**RE: 2 Alikhani, Naser – Home
1200 Hideaway Lane SE
Grading and Drainage Plan
Engineer's Stamp Date: 08/17/21
Hydrology File: M23D017A**

Based upon the information provided in your submittal received 08/18/2021, the Grading & Drainage Plan **is not** approved for Building Permit and Grading Permit. The following comments need to be addressed for approval of the above referenced project:

**RE: 2 Alikhani, Naser – Home
1200 Hideaway Lane SE
Grading and Drainage Plan
Engineer's Stamp Date: 06/21/21
Hydrology File: M23D017A**

SHEET 2 OF 2

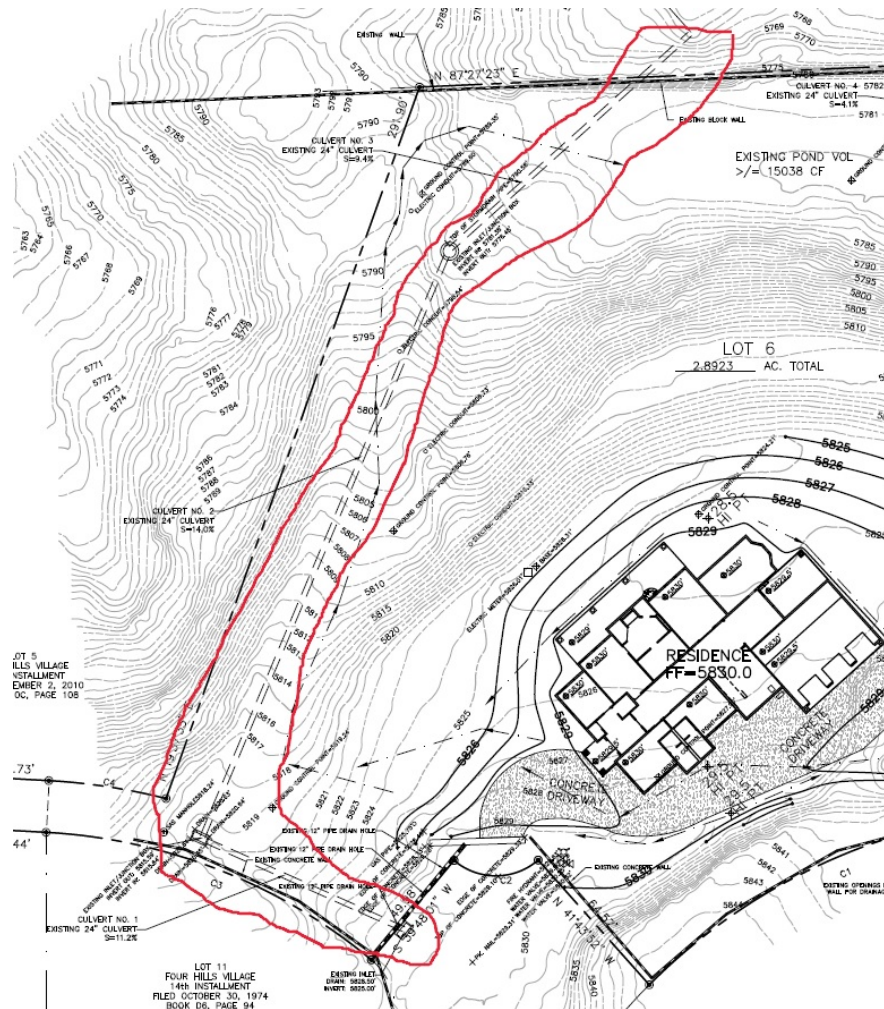
4. I also looked into the Work Order plans for Hideaway Lane (CPN 523381). The work order only had the construction of the Loman and the end piece of Hideaway (which Lot 6 will access their lot from). As shown below from February 2011 aerial photo. There was no storm sewer designed for this Work Order and the drainage was to follow the Drainage Report noted in Comment #1. That being said, there is an existing inlet was installed in the Public R.O.W. of Hideaway Lane. The City again does not have any records of the construction of this inlet and the City currently does not maintain this inlet since it was illegally installed. The drawing that was provided was done by BHI but there was no engineer's signature on the drawing. Regardless, this storm drain and pipe carries **Public Stormwater and the inlet and pipe were not constructed to City of Albuquerque standards.** This will have to be designed and submitted to the both Hydrology for Work Order review and Design Review & Construction (DRC) for review and approval. Also the storm drain must be in a Public Drainage Easement.

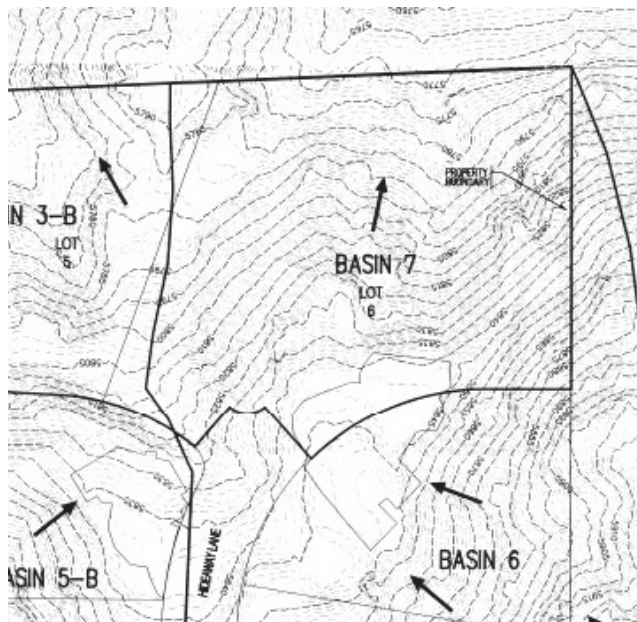
1. This lot is part of the Drainage Report for Four Hills Village 21st Installment by Bohannon Huston dated May 22, 2009 (M23D017). This drainage report states that each lot is required to pond developed flow greater than existing flow, so for lot 6 the existing flows is 9.62 cfs and that the lot is to discharge to the northeast as historic flow pattern. (see below).

The site has been designed to pond the amount of runoff due to the development of the property.

March 2012

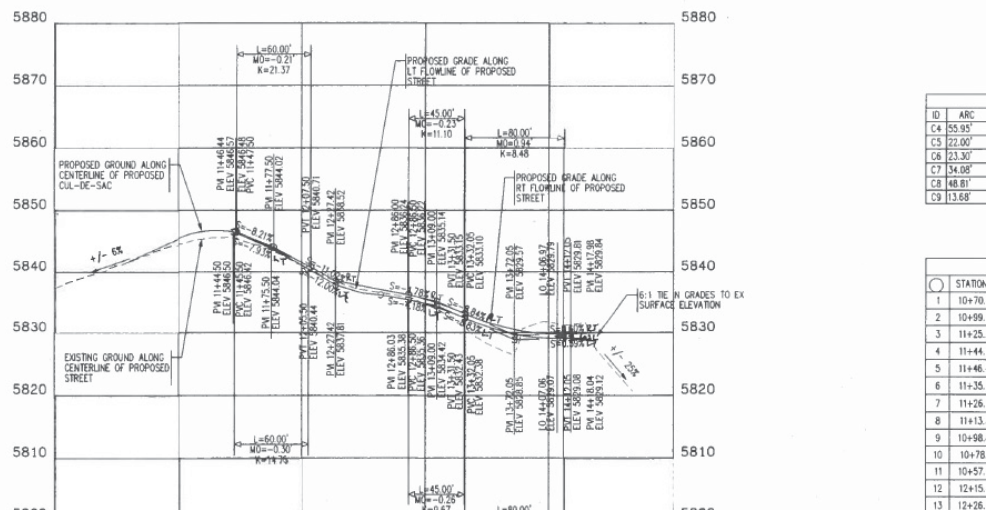
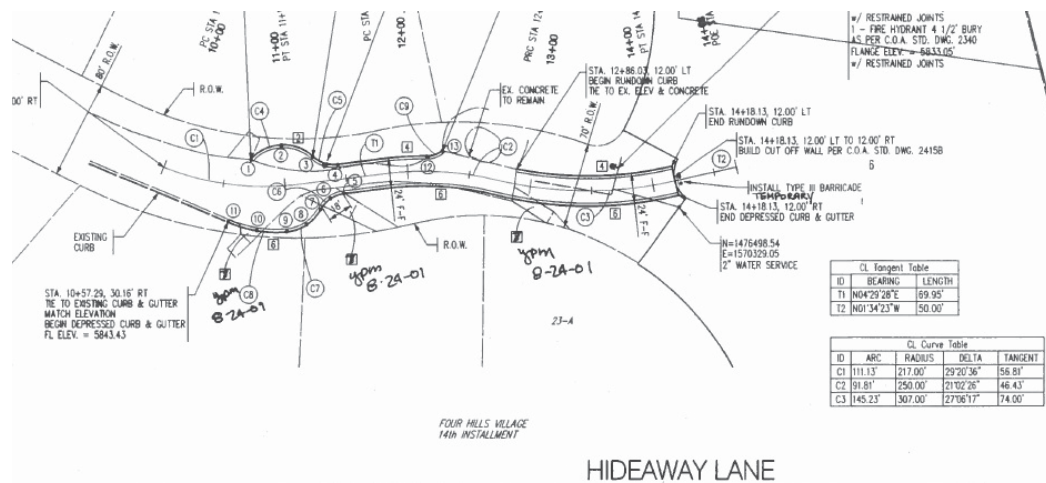
4. I also looked into the Work Order plans for Hideaway Lane (CPN 523381). The work order only had the construction of the Loman and the end piece of Hideaway (which Lot 6 will access their lot from). As shown below from February 2011 aerial photo. There was no storm sewer designed for this Work Order and the drainage was to follow the Drainage Report noted in Comment #1. That being said, there is an existing inlet and a wall with three large holes at the bottom for drainage that was installed in the Public R.O.W. of Hideaway Lane. The City again does not have any records of the construction of this inlet and the City currently does not maintain this inlet since it was illegally installed. I also currently don't know where the inlet (the Public waters from Hideaway) discharges to. I need some kind of solution to this matter and this will hold up the house Building Permit since the wall appears to have been installed sometime in 2012. See March 2012 aerial photo below.

Attached is a design map by BHI (Bohannon-Huston), who designed the layout of the existing drainage culverts for the offsite flow. I could not find any as-builts for this, but the intent of the design by BHI has been achieved.
